# Office Action Summary

10/518,521

A method of generating a flame in a combustion zone of a rotary kiln comprising:

JP 51- 136716 shows:

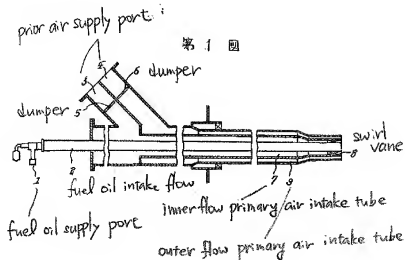
**JP 51- 136716** shows and discloses a burner lance (2) is provided for introducing fuel into the burner tube (9) for combustion with primary air to generate a flame at the discharge end of the burner tube within the combustion zone of a rotary kiln (11), and wherein a flue gas (14) is directed to the burner tube so that the flue gas is used as primary air for combustion of the fuel introduced into the burner tube by the burner lance where it is combusted with the fuel as primary air to generate a flame at the discharge end of the burner tube in the combustion zone of the rotary kiln.

**DE 100 62 066** shows:

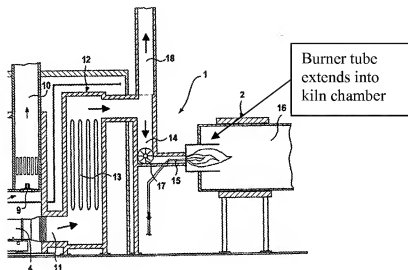
**DE 100 62 066** teaches, from applicant's same combustion fired furnace field of endeavor, a burner lance (15) is provided for introducing fuel into the burner tube (not referenced) for combustion with primary air to generate a flame at the discharge end (not referenced) of the burner tube, and wherein a flue gas (11, 12, 14) generated by a gas turbine (4) located outside the kiln wall (16) which in turn is directed to the burner tube so that the flue gas is used as primary air for combustion of the fuel introduced into the burner tube by the burner lance where it is combusted with the fuel as primary air to generate a flame at the discharge end of the burner tube in the combustion zone of the rotary kiln. **DE 100 62 066** discloses a cement manufacturing installation comprises a rotating oven (2) having a rotating pipe (16) heated using a burner (15); and a gas turbine arrangement (4) driven by a generator to produce electrical energy. A pipe connection (12) is arranged between an exhaust gas outlet (11) of the gas turbine

arrangement and a combustion air inlet (14) of the burner. The exhaust gas is introduced as combustion air via the pipe connection.

**Fig. 2**

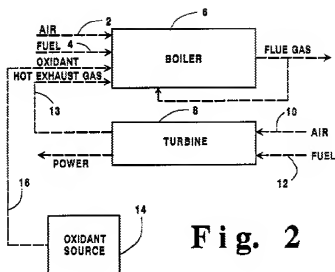
800 °C) can be viewed as nothing more than merely a matter of choice in design absent the showing of any new or unexpected results produced therefrom over the prior art of record. Alternatively, regarding claim 2, Official Notice is taken that turbine exhaust gas temperature are known to fall within the claimed temperature range of 400-800 °C, or 752-1492 °F. (See for example, US 6200128: "A typical turbine exhaust gas will have a temperature of about 1000 to 1100.degree. F ...").
